## ADDENDUM NO. 1

PROJECT: Saline Area Schools – 2022 Bond Program – MS Rec Complex  
 DESCRIPTION: Addendum No.1  
 BID PACKAGE RELEASE NUMBER: BP #3

1. ADDENDUM No. 1, November 20<sup>th</sup>, 2024 as issued by Kingscott (Attached)
2. Bid Package T4 Draft Drawings, October 22<sup>nd</sup>, 2024 - Saline Middle School Rex Complex as issued by Barton Malow (For Reference Only)

SHEET NO.  
**L3.05**

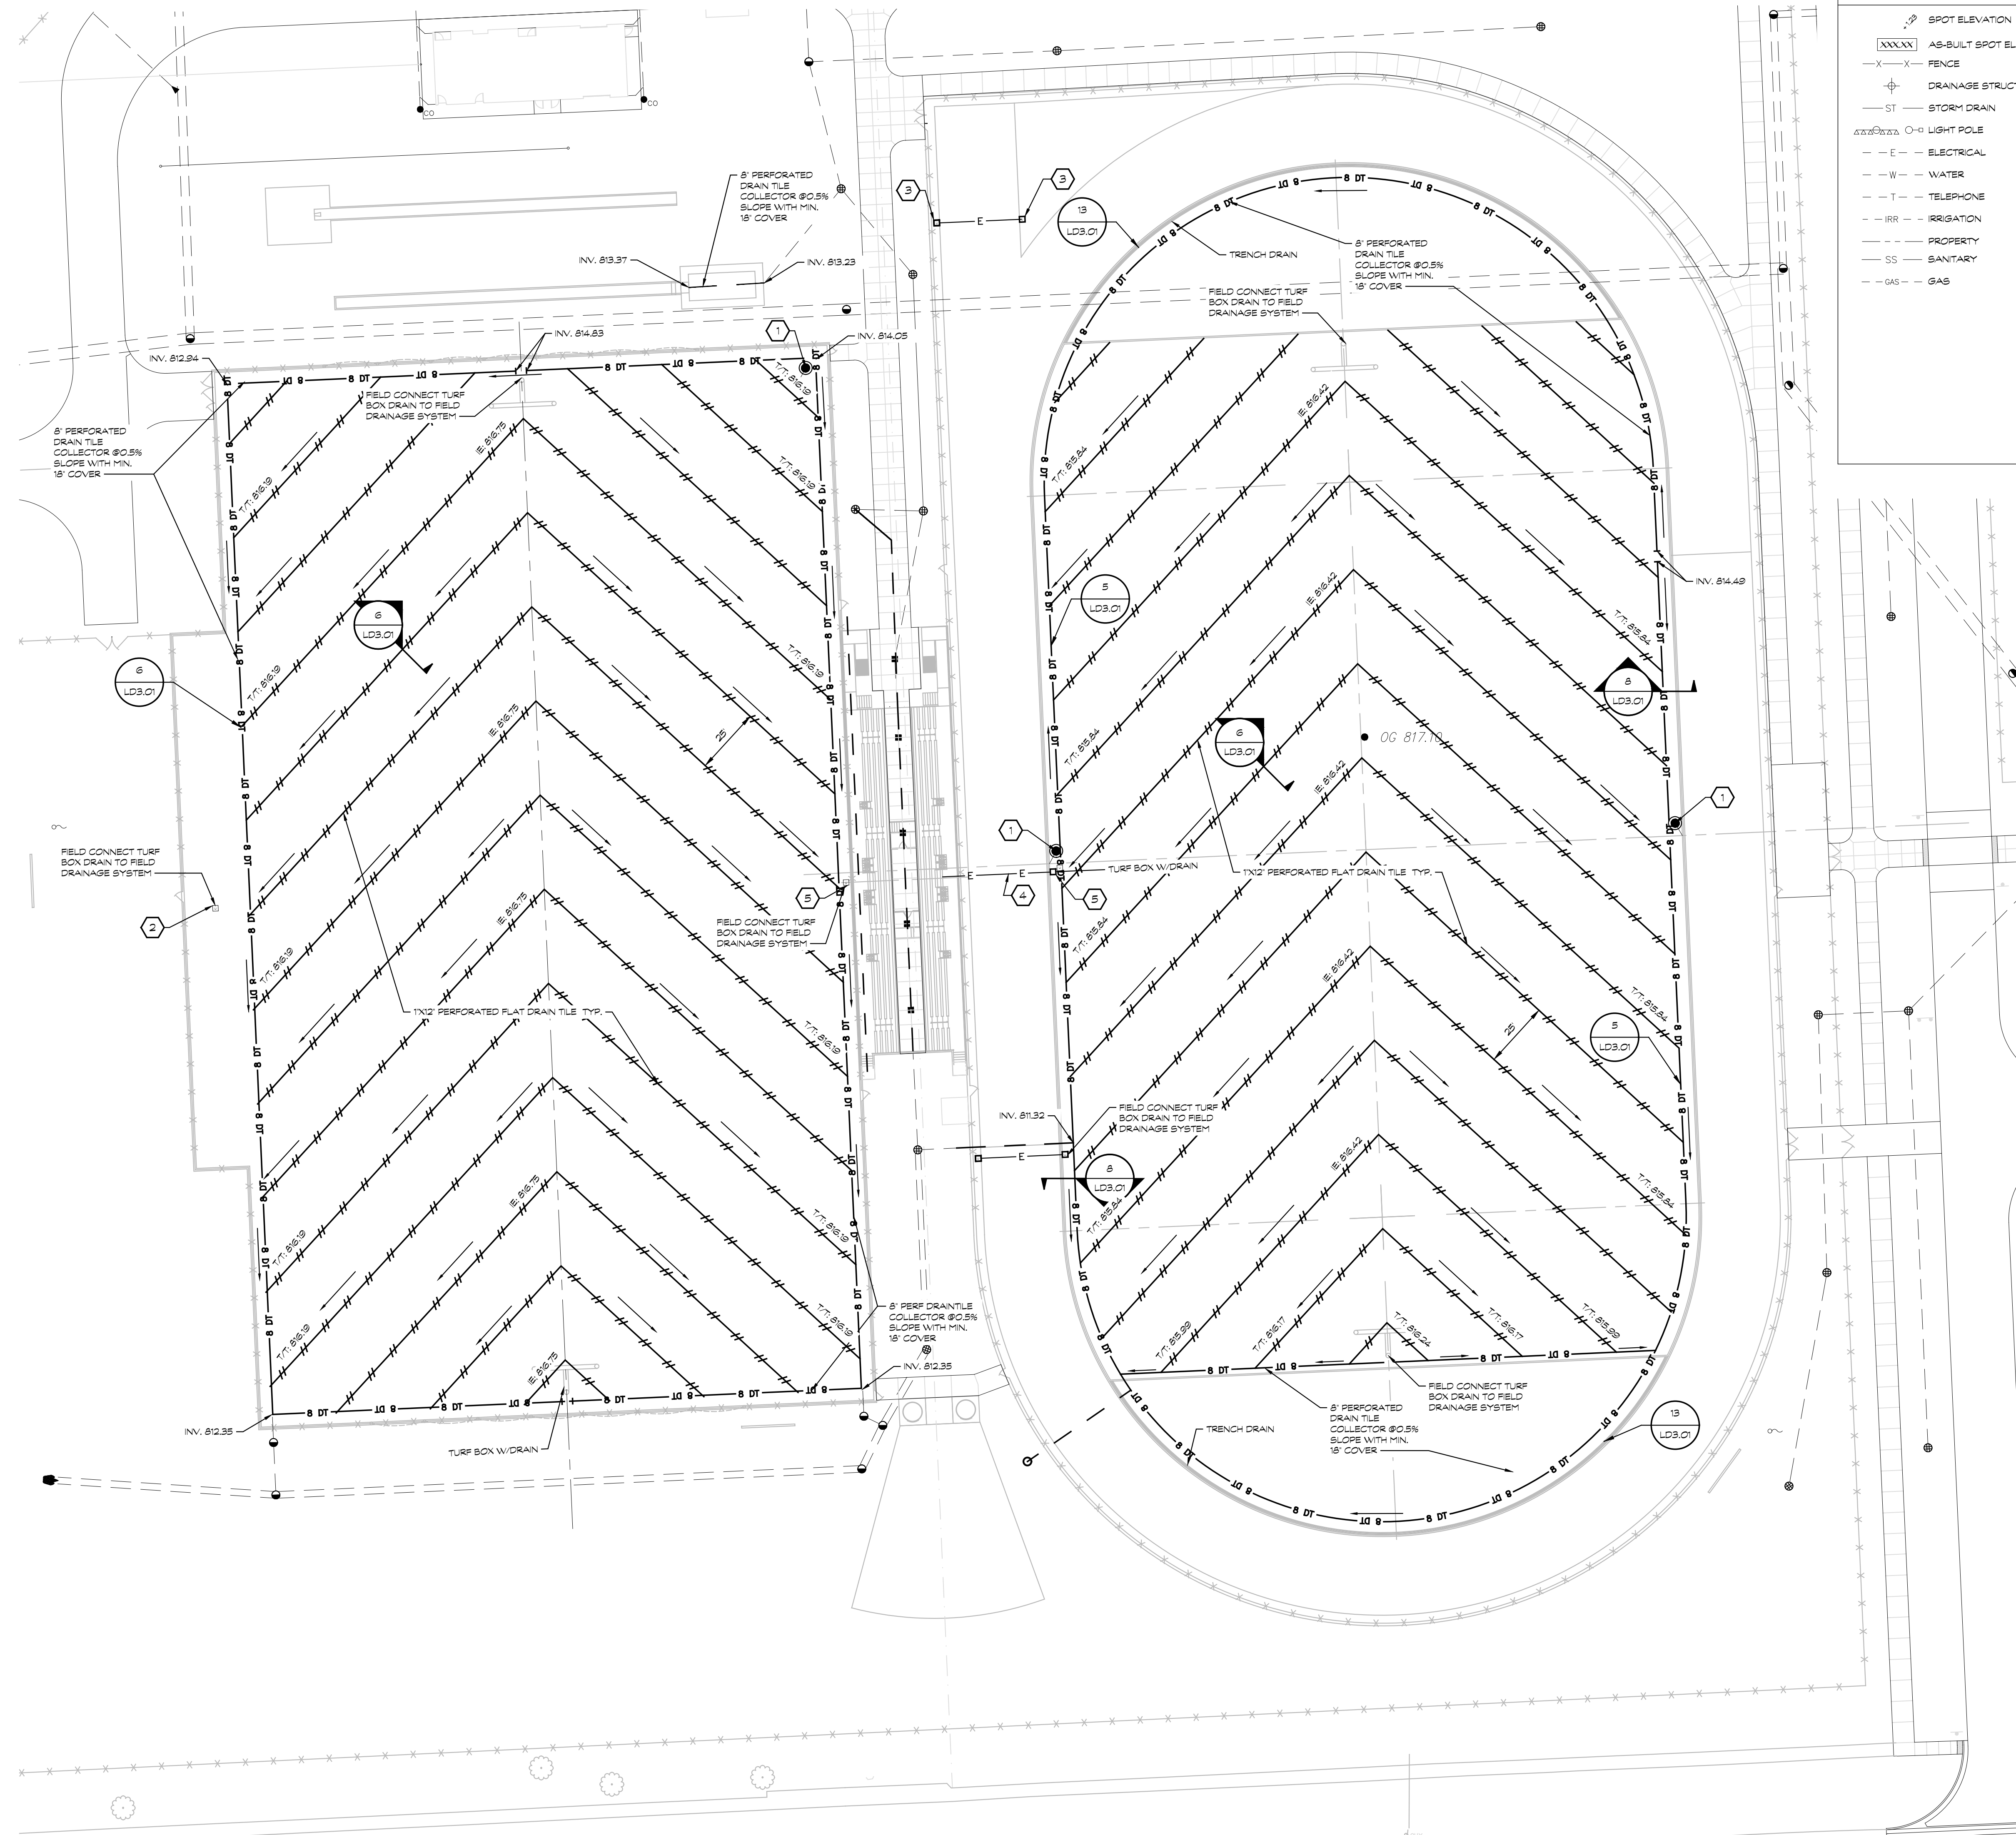
- Item No. 85: Added spot grade elevations on sheet L3.04.
- Item No. 86: Revised inverts and outlet locations to coordinate with civil on sheet L3.05.
- Item No. 87: Revised specification section 13 3500 Grandstands to align with design intent.
